# COFFS HARBOUR CITY COUNCIL

Our ref: 2737356 (DA 700/11)

**MP 08-0080, Residential Subdivision  
Lot 112, DP 1073791, Lyons Road, North Bonville**

Council refers to the above Major Project Application and to the Departments request for comment on the Environmental Assessment.

# sawtell park estate stg. 2 - north bonville

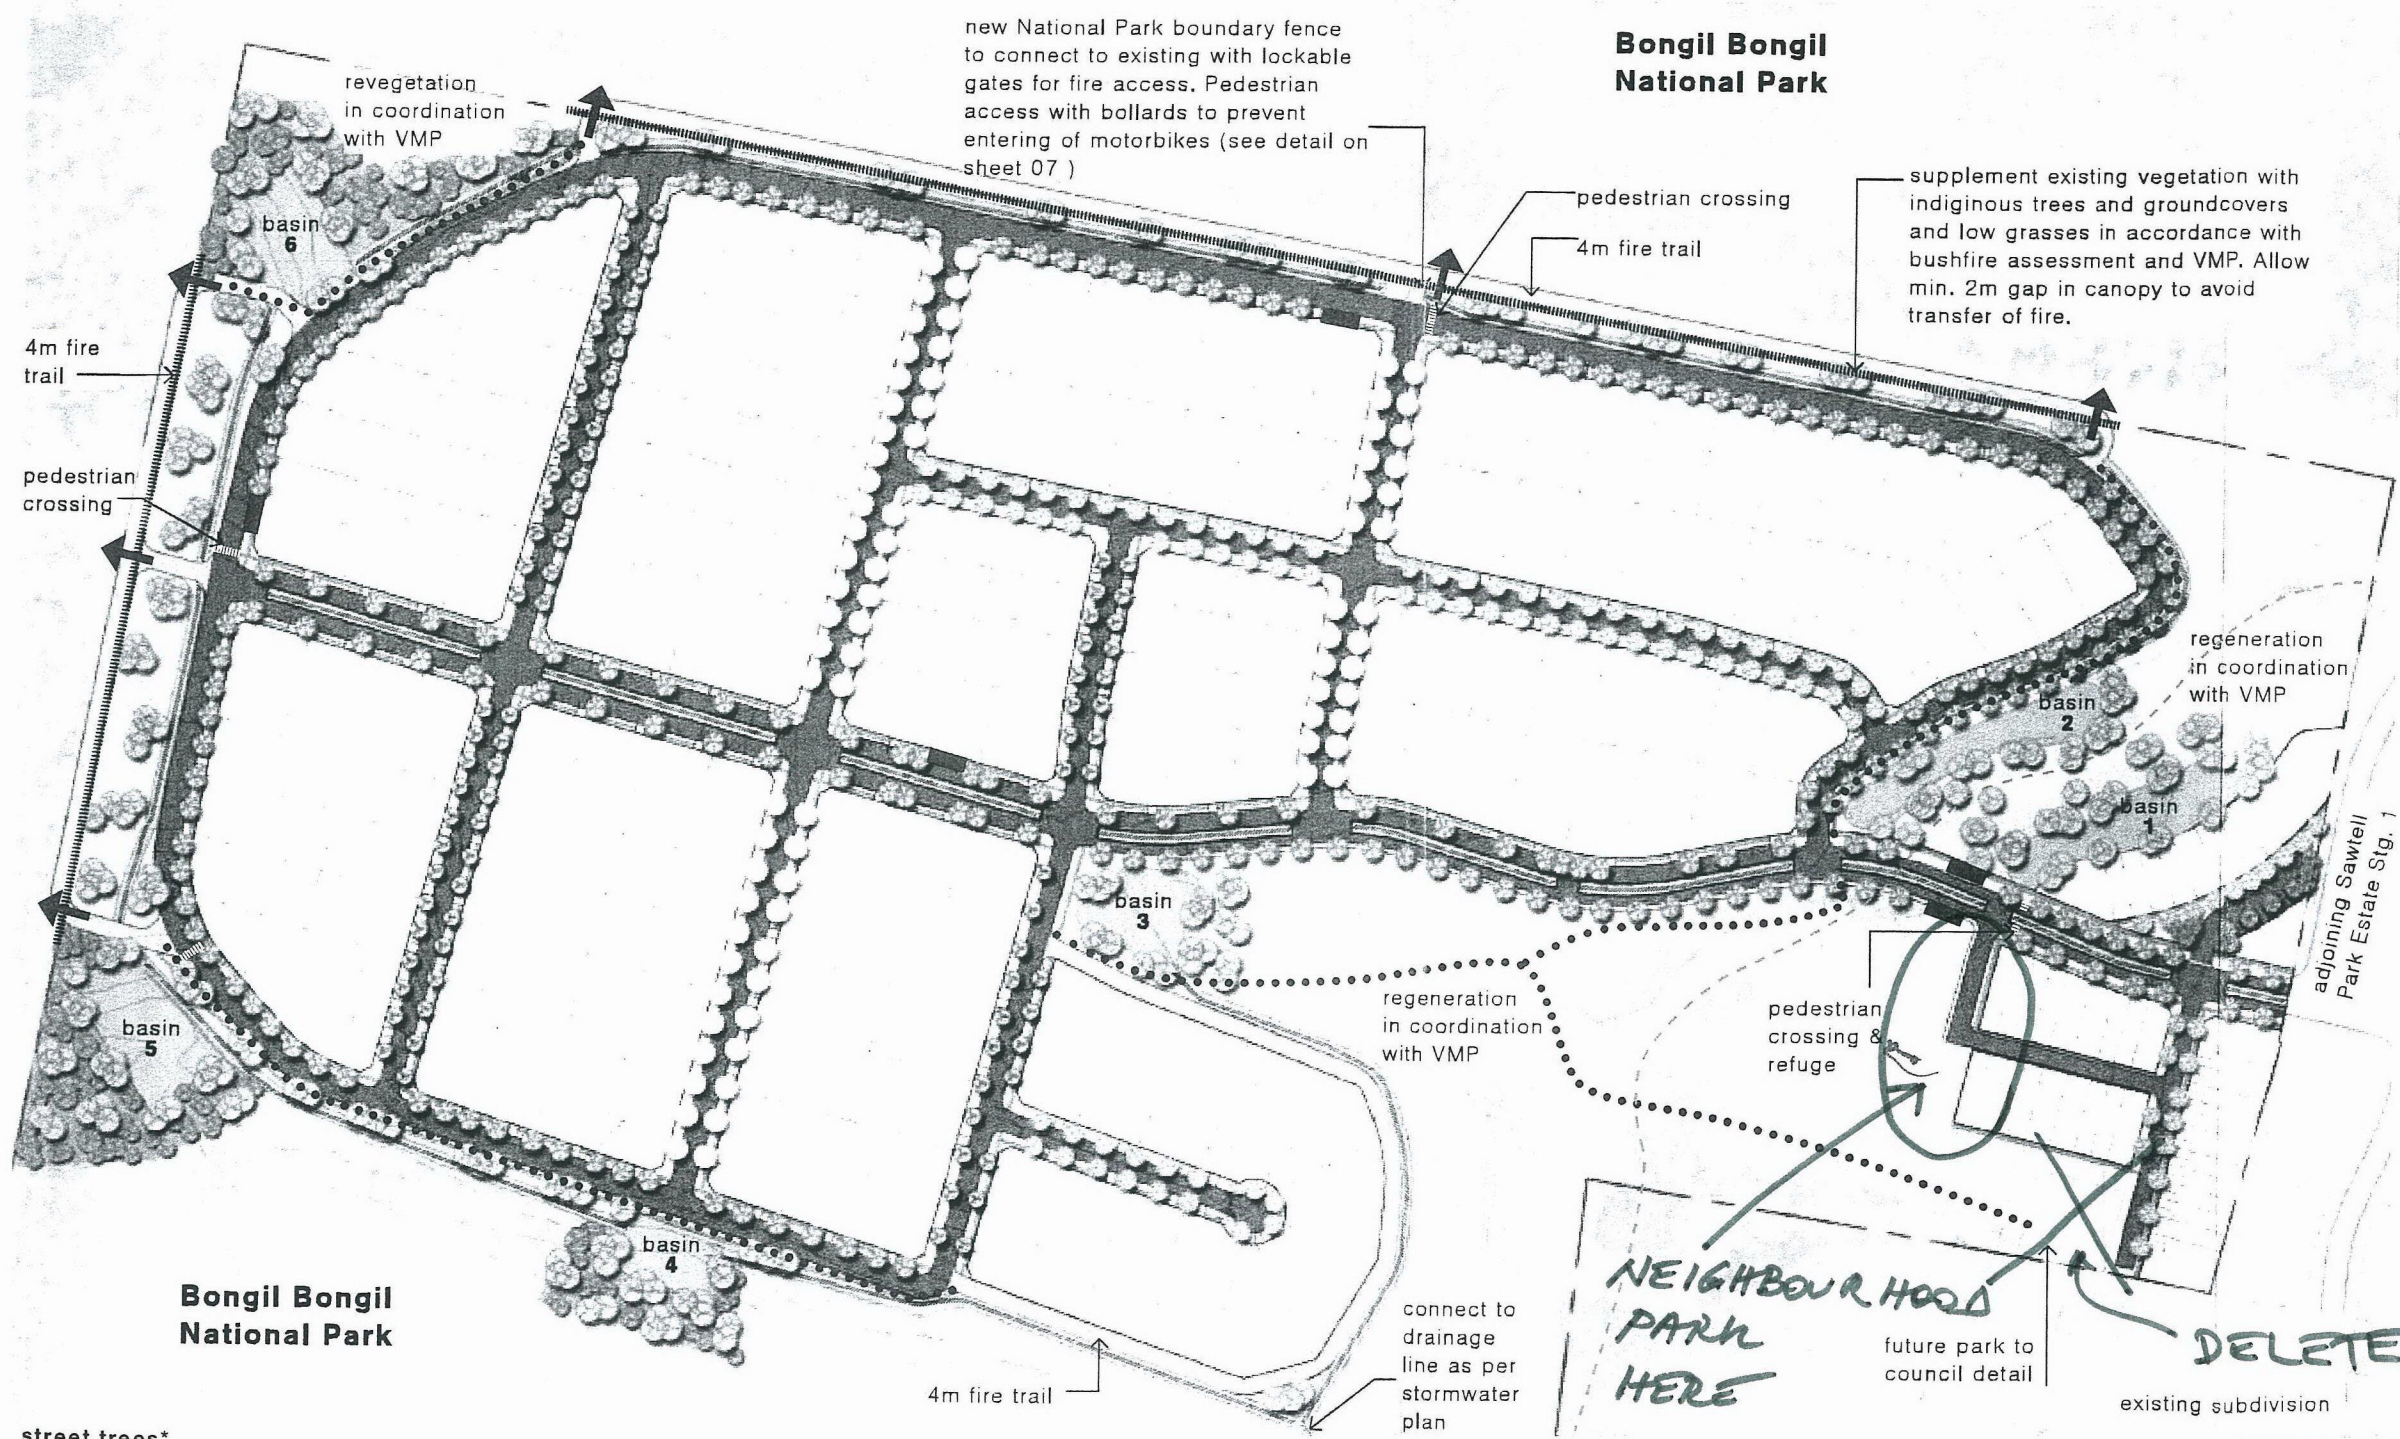
The location of the proposed neighbourhood park is unacceptable to Council. The proposed park (shown on the landscape plan) is too small, lacks visibility and natural surveillance and has no kick-around space.

Council supports an alternative possible location for the neighbourhood park as detailed in Appendix A to this letter. The suggested location is positioned adjacent to the main collector road and in proximity to the riparian area. The majority of the suggested location is to be situated at or above the 1:100 AEP event. Some encroachment into the medium density community title lots is required for this location.

That area currently detailed as neighbourhood park in the Project Application may be investigated for additional residential subdivision (as medium density community title) as an offset to that allocated to the revised park's location and configuration.

NEIGHBOURHOOD PARK HERE  
 DELETE - INVESTIGATE FOR MEDIUM DENSITY COMMUNITY TITLE

The proponent should review the neighbourhood park's position and configuration in consultation with Council's Recreation Services Section (contact Sue Stewart on telephone 6648 4875). Council staff are prepared to consider any viable alternative park locations in consultation with the proponent.
